11-4-2020 - (R2) - CHANGED MARQUEE MOLEX CONNECTOR FROM 2 PIN TO 3 PIN TO ADD 5V TO THE PLUG.

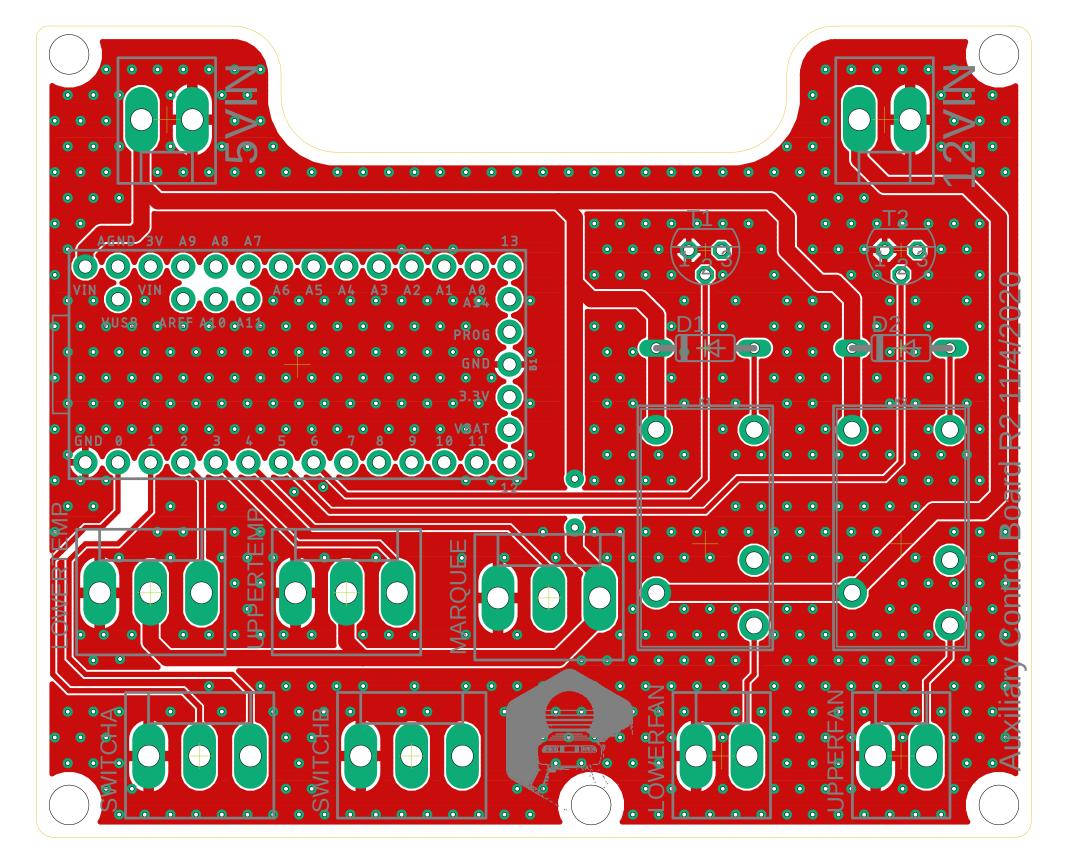
11-4-2020 - (R2) - CHANGED MARQUEE MOLEX FROM 2 PIN TO 3 PIN TO ADD 5V TO HEADER. 5VIN WAS CHANGED FROM .8068 THICKNESS TO 1.27 FOR ADDITIONAL POWER NEEDS

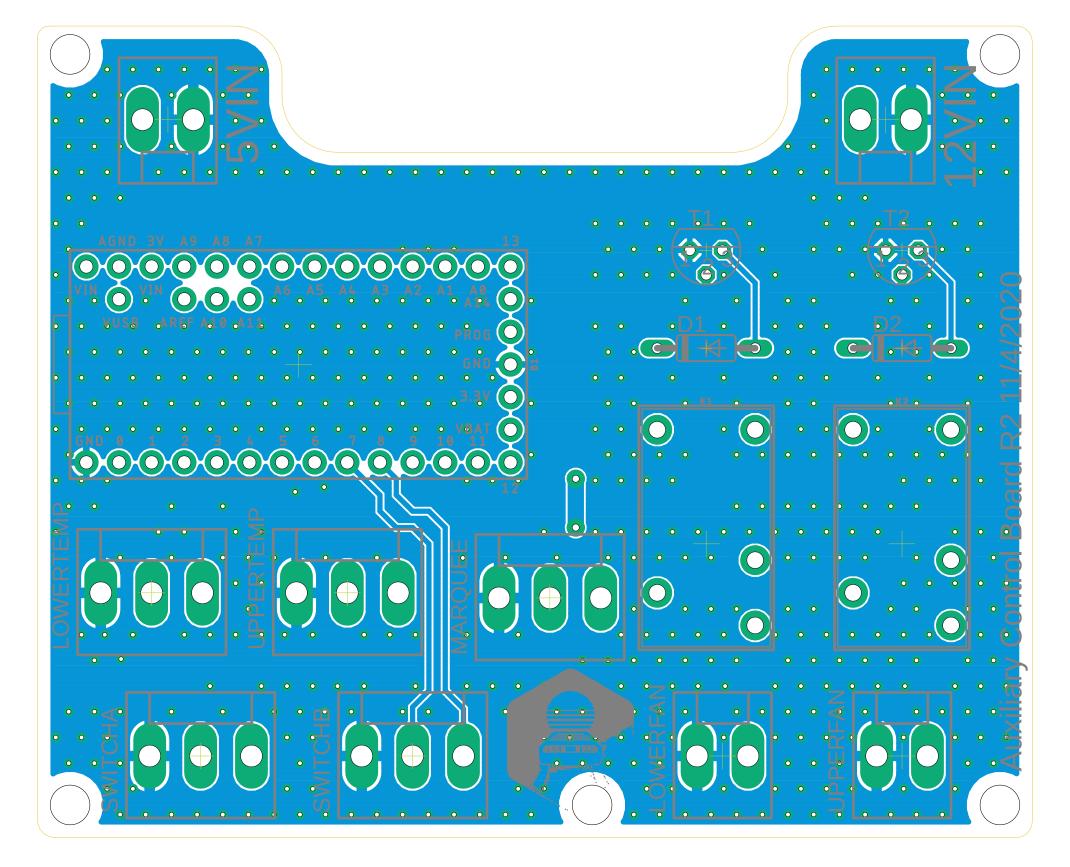
11-4-2020 - (R2) - CHANGED MARQUEE MOLEX FROM 2 PIN TO 3 PIN TO ADD 5V TO HEADER. 5VIN WAS CHANGED FROM .8068 THICKNESS TO 1.27 FOR ADDITIONAL POWER NEEDS
